UNITED STATES PATENT AND TRADEMARK OFFICE

APPLICATION NO.	FILING DATE	FIRST NAMED INVENTOR	ATTORNEY DOCKET NO.	CONFIRMATION NO.
10/695,011	10/28/2003	Vaughn L. Bauer	2-5751-001	4258
803	7590	08/04/2006	EXAMINER BATSON, VICTOR D	
STURM & FIX LLP 206 SIXTH AVENUE SUITE 1213 DES MOINES, IA 50309-4076			ART UNIT 3671	
PAPER NUMBER

Office Action Summary	Application No.		Applicant(s)	
	10/695,011		BAUER, VAUGHN L.	
	Examiner		Art Unit	
	Victor Batson		3671

FIG. 3

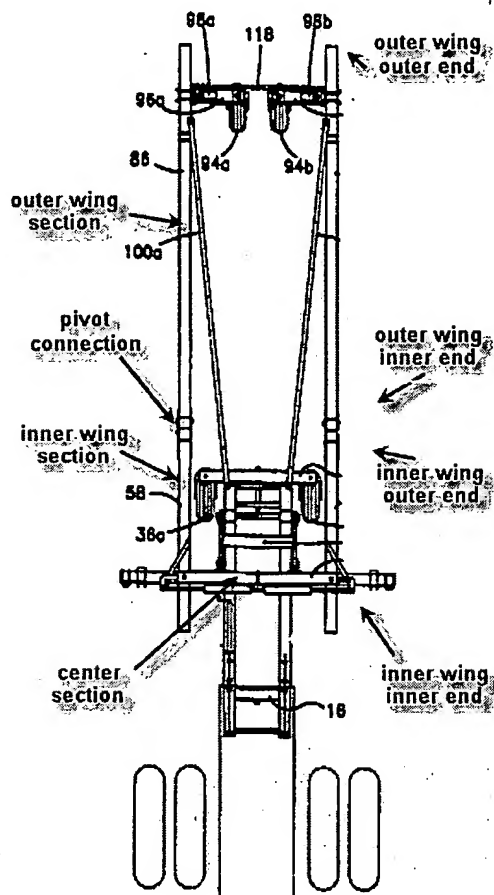
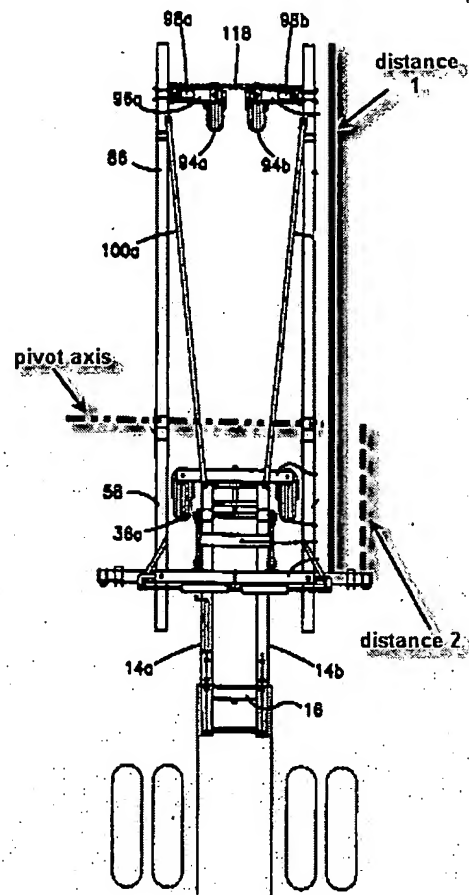
Kirwan discloses a forwardly folding toolbar comprising a tongue, a center section, outer wing sections, inner wing sections, with a distance between the outer end of the outer wing section and the inner end of the inner wing section greater than a distance between the inner end of the outer wing section and the inner end of the inner wing section. Concerning the method claims, given the structure of Kirwan, the claimed method steps would inherently be performed while the device of Kirwan was assembled and operated. Concerning the claimed actuators, figure 8 discloses the use of actuators

for raising the pivot points relative to the ground engaging wheels. Concerning the claimed latch, transport securement bar 118 is considered a latch.

distance 1 > distance 2
